IEEE P802.3ct Terminology (Part II) Ad hoc Teleconference Meeting

Definitions Update

IEEE P802.3ct Terminology (Part II) Ad hoc, 12 February 2021

Figure 154-3—Black link example configuration for specifying n DWDM channels

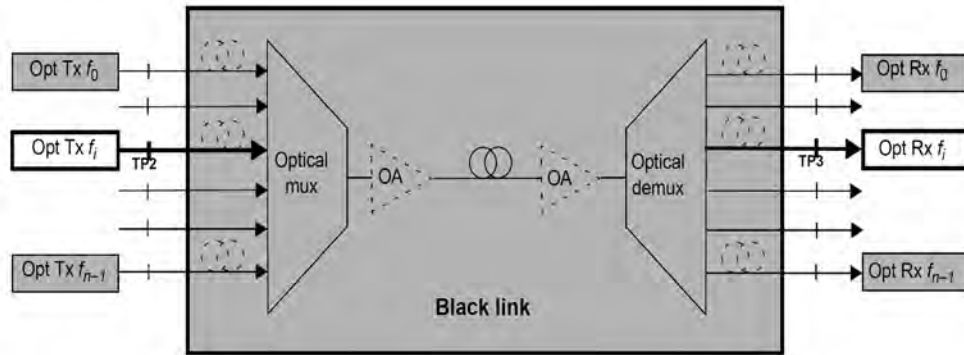
- D3.1 denotes this as “Black link”
- Proposed to change “Black link” to “Black link approach”
- Current suggestions for renaming the “grey box”:
 - DWDM link ([dambrosia 3ct 01 210204](#))
 - DWDM black link ([stassar 3ct 01 210204](#))

Proposal:

- 1) Change name of “grey box” from “Black link” to “DWDM black link”
- 2) Define “DWDM black link” as “**DWDM black link**: An aggregate of DWDM channels over either a single optical fiber or a single optical fiber per direction”

Open questions on “DWDM black link”

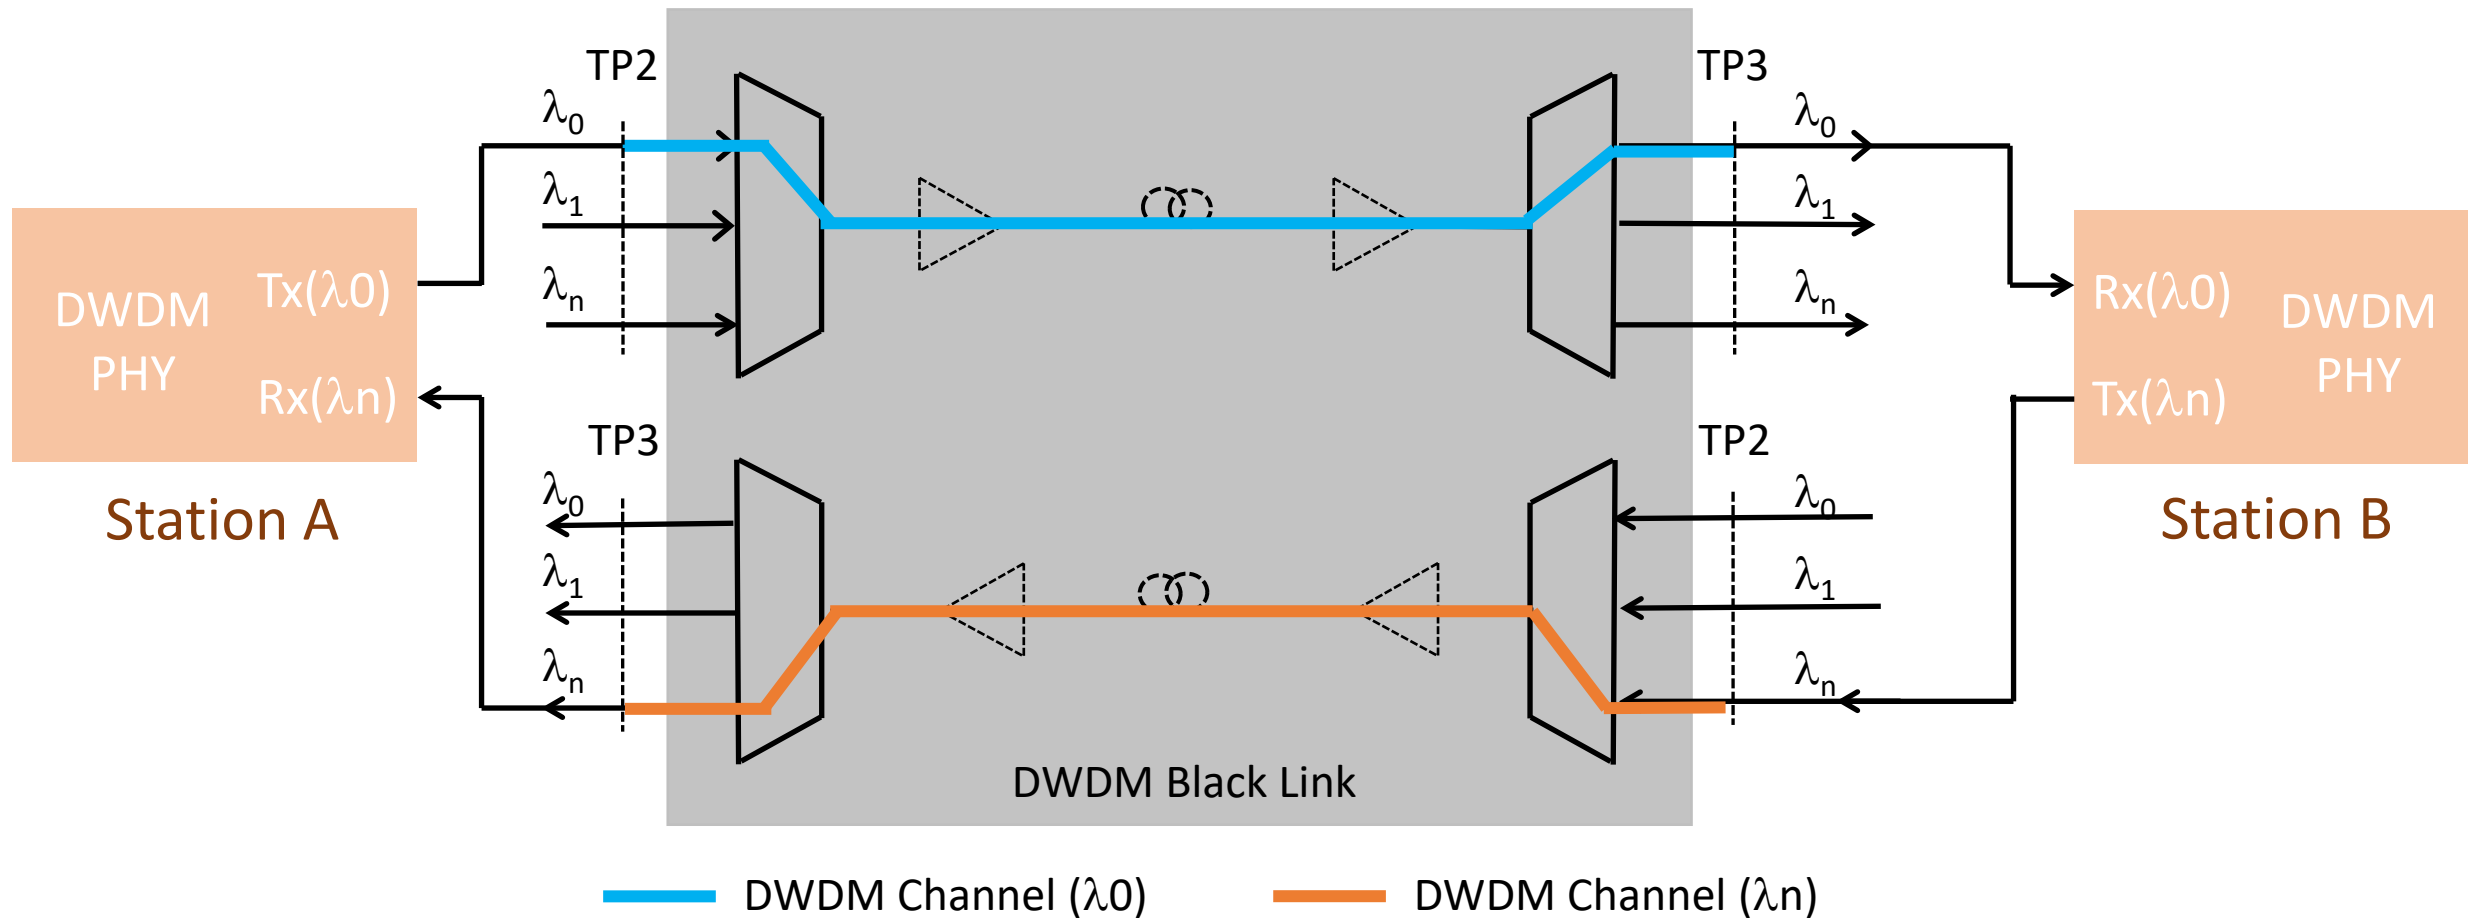
- Is it necessary to define or show that the DWDM Black Link is uni-directional (one fiber for each direction or transmission), or bi-directional (one fiber for both directions of transmission) at the physical level ?
 - Probably not, because by definition the link is black and therefore the internals are not specified
 - But it would be useful to have some typical implementation examples of a DWDM Black Link shown in an informative annex (e.g. 83C, 85A, etc)
- Is it necessary to show that the DWDM Black Link is bi-directional at the black box level, i.e. has nxTP2 inputs on the left side and nxTP2 inputs on the right side ?
- Do we need to say anything about the number of DWDM channels (i.e. TP2 and TP3 ports) that a DWDM Black Link supports (as this may be different depending on whether the internal implementation is based on one fiber or two fibers ?
